# UNITED STATES PATENT AND TRADEMARK OFFICE

APPLICATION NO.	FILING DATE	FIRST NAMED INVENTOR	ATTORNEY DOCKET NO.	CONFIRMATION NO.
10/608,255	06/27/2003	Belgacem Haba	SIPI-P107	8350
30554	7590	09/02/2004	EXAMINER	
SHEMWELL GREGORY & COURTNEY LLP 4880 STEVENS CREEK BOULEVARD SUITE 201 SAN JOSE, CA 95129			ZARROLI, MICHAEL C	
			ART UNIT	PAPER NUMBER
			2839

<b>Office Action Summary</b>	<b>Application No.</b> 10/608,255	<b>Applicant(s)</b> HABA ET AL.	
	<b>Examiner</b> Michael C. Zarroli	<b>Art Unit</b> 2839

## DETAILED ACTION

**FIG. 12C**

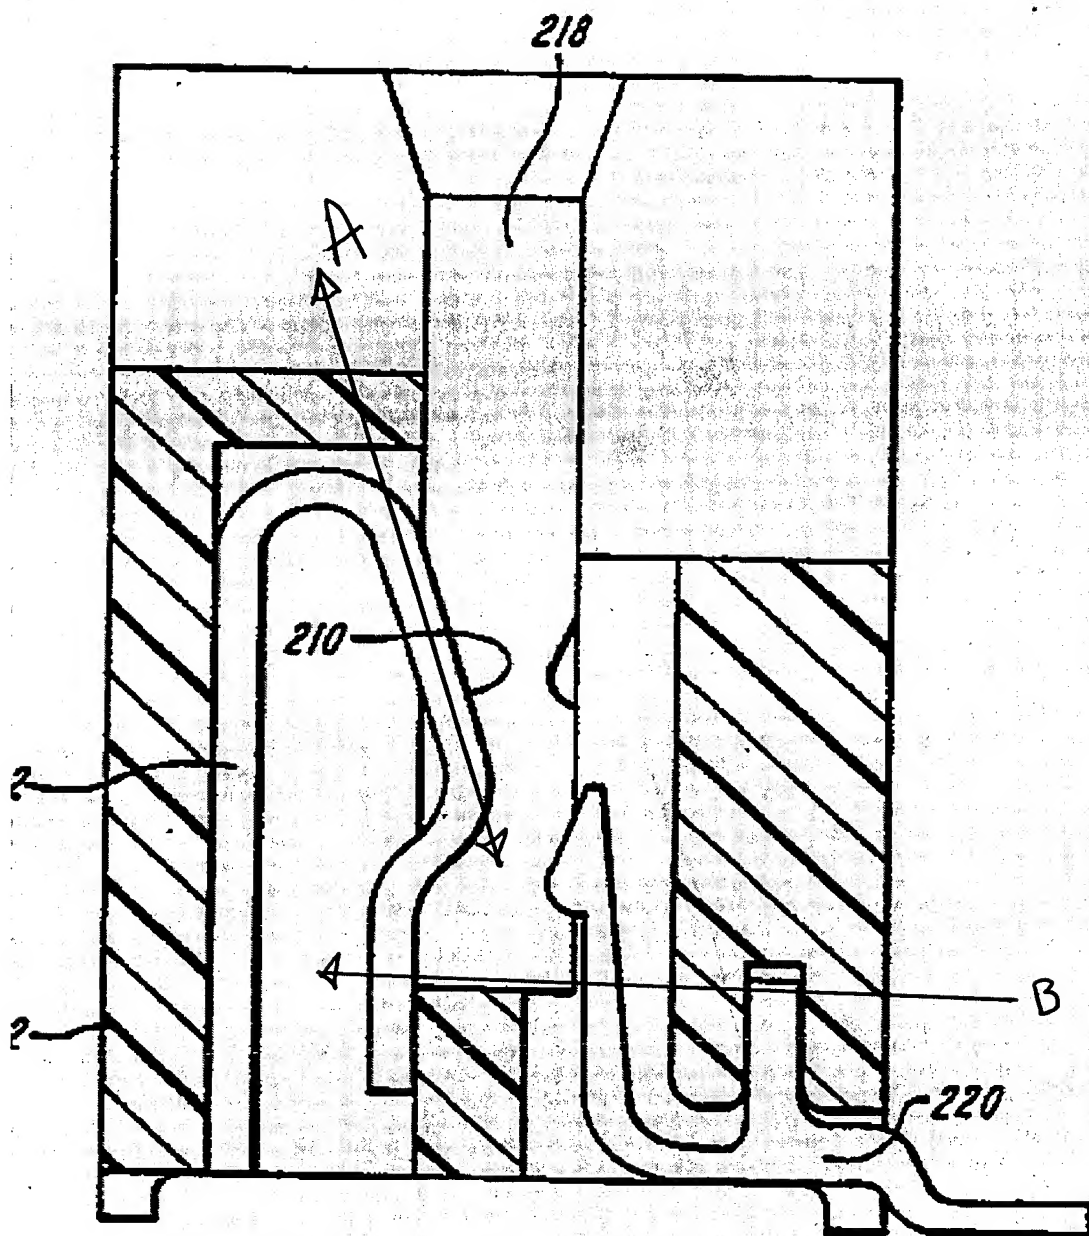
Regarding claims 4-5 and 10-11 Pickles discloses (see copy of fig. 12C from Pickles below) that before the insertion force is applied, the plurality of elements include a set of elements that have a first skewed orientation (arrow A below) with respect to a primary direction in which the insertion force is to be applied (218), and wherein the set of elements are aligned to increase in skew when affected by the insertion force and after the insertion force is applied (arrow B), the set of elements are biased to reduce in skew towards the first skewed orientation.

Regarding claim 9 Pickles discloses that the first interior surface and the second interior surface oppose one another across the cavity (fig. 12C).

Regarding claim 12 Pickles discloses that the member of each element in the plurality of elements is configured to have a bias towards becoming less skewed (vertical direction in fig. 12C as outlined in the 112 rejection above) after the

insertion force is applied (also vertical) and the mating component is inserted (fig. 10A), and wherein the bias (more towards vertical) coincides with the coupling structure pressing against the mating component (fig. 7).
